**CHANGE ORDER NO. 2  
STILL CREEK WASTEWATER IMPROVEMENTS - PHASE III  
CITY JOB NO. 411-D4-1102**

**May 12, 2015**

<b>FORCE MAIN PLAN &amp; PROFILE</b>	
		STILL CREEK WASTEWATER IMPROVEMENTS-PHASE III	
DRAWN BY: PSE		DATE: JAN / 2015	
APPR BY: B.W.		SCALE: 1"=30'H 1"=3'V	
PROJECT NO: 411-D4-1102			
REV.	DATE	DESCRIPTION	SHEET
1	5/12/15	ADDED 12" & 20" PIPE & VALVES	1
			2

**FORCE MAIN CONNECTION DETAILS**  
STILL CREEK WASTEWATER IMPROVEMENTS-PHASE III

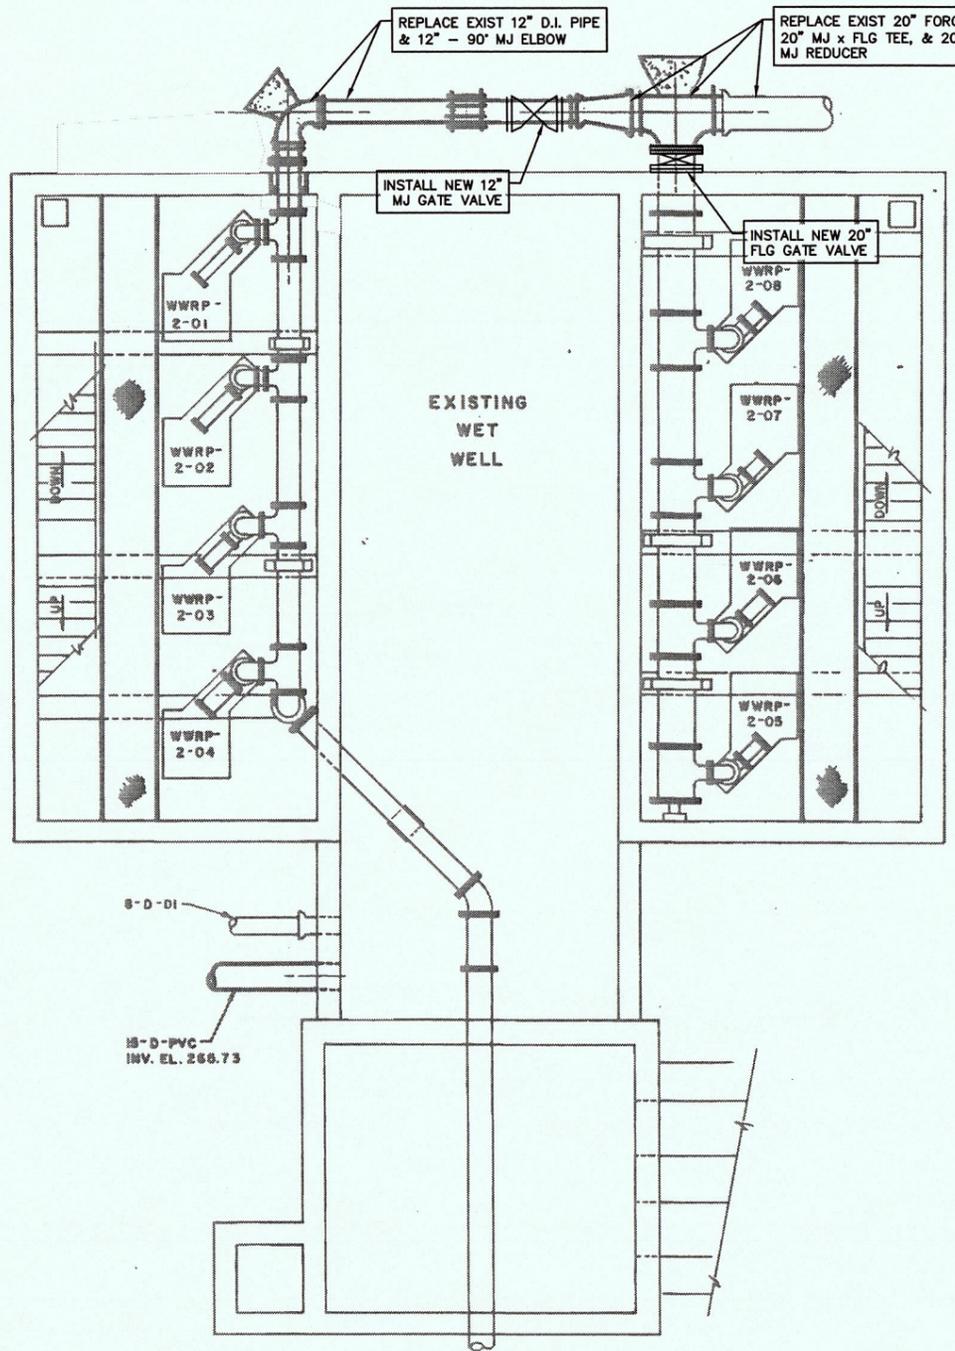
1. CONTRACTOR TO REMOVE AND REPLACE EXISTING FORCE MAIN IN CURRENT LOCATION AS SHOWN.
2. CONSTRUCTION TO BE COORDINATED WITH OWNER. CONTRACTOR TO CONTACT OWNER A MINIMUM OF 48 HOURS IN ADVANCE OF WORK.
3. ELEVATIONS SHOWN OF EXISTING PIPING ARE APPROXIMATE, CONTRACTOR TO VERIFY.
4. CONTRACTOR TO PROVIDE, CONNECT, AND MAINTAIN TEMPORARY BY-PASS LINE FROM THE 12-INCH DISCHARGE OF RAW WASTE LIFT STATION TO THE INTERMEDIATE CLARIFIER WET WELL.
5. CONTRACTOR TO EXERCISE CAUTION WHEN WORKING IN VICINITY OF EXISTING ACTIVE PIPELINES.
6. CONTRACTOR TO PROVIDE A 20-INCH COMPRESSION COUPLING (DRESSER) AND CONNECT EXISTING 20 INCH D.I.P. TO NEW D.I.P. IF REQUIRED TO MEET FLOW DEMANDS OR DURING EXTENDED PERIODS OF WORK SUSPENSION. COORDINATE WITH OWNER.

**RAW WASTE PUMP STATION**  
SCALE: 1/4" = 1'-0"

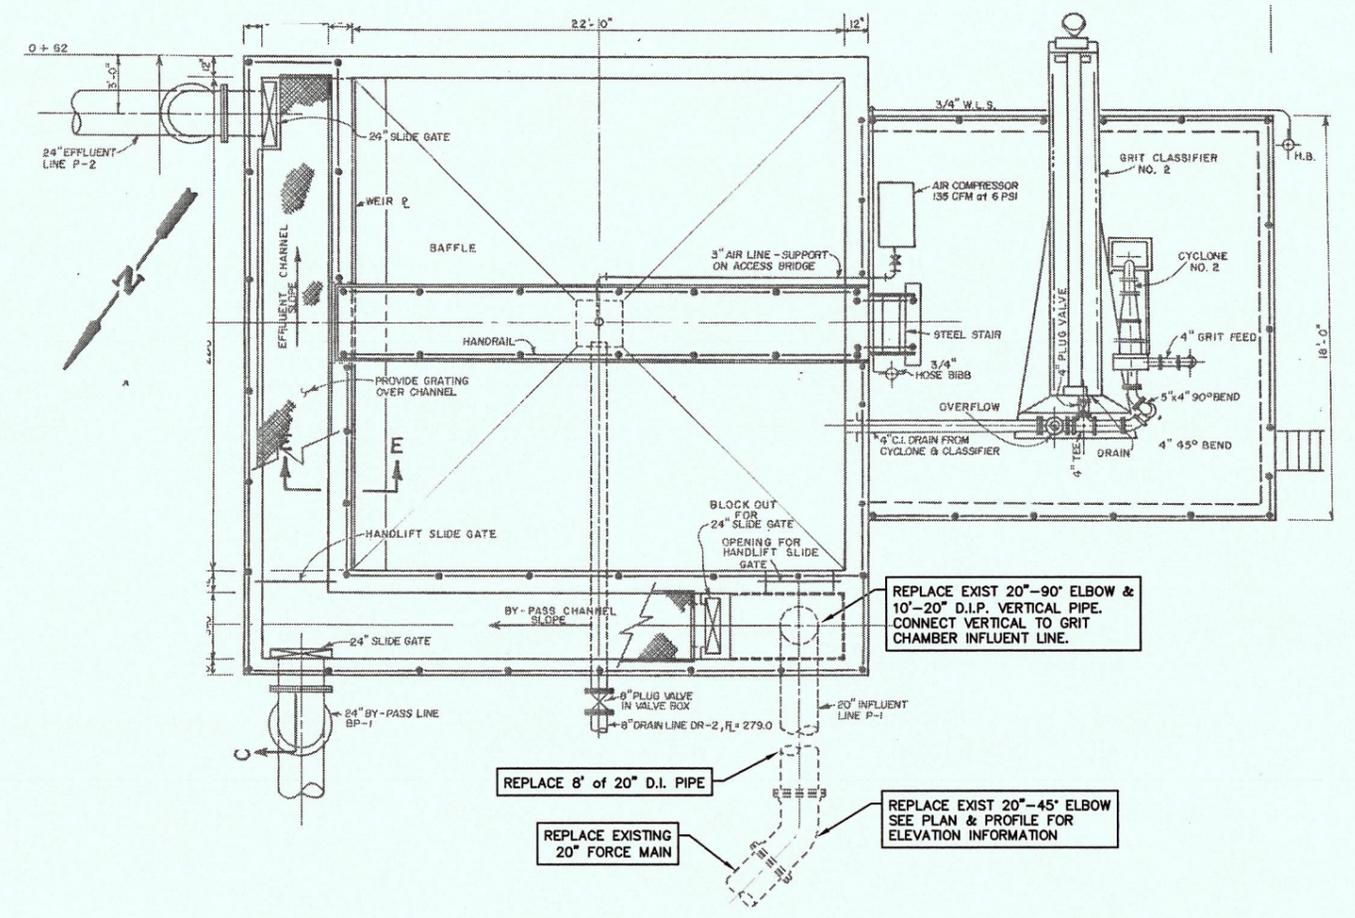
CO2-10	1	EA	20" AWWA C515 Flg X Flg Gate Valve at pump station header	\$14,425.00	\$14,425.00
CO2-11	1	EA	12" AWWA C515 MJ X MJ Gate Valve at 20"X12" tee at pump station.	\$2,120.00	\$2,120.00
CO2-12	225	SF	Remove and replace asphalt pavement includes cement stabilized sand	\$18.00	\$4,050.00
CO2-13	575	SF	Remove and replace concrete parking area includes cement stabilized sand	\$19.00	\$10,925.00
CO2-14	1	LS	Remove and replace existing 18" steel culvert	\$800.00	\$800.00
CO2-15	1	LS	Connect to existing vertical connection 20 " DIP at Grit Basin.	\$3,235.00	\$3,235.00
CO2-16	1	LS	Remove and dispose of Odor Control Unit and Slab	\$5,000.00	\$5,000.00
				<b>TOTAL CO #2:</b>	<b>\$245,870.00</b>

REV.	DATE	DESCRIPTION	SHEET
1	5/12/15	ADDED 12" & 20" PIPE & VALVES	2
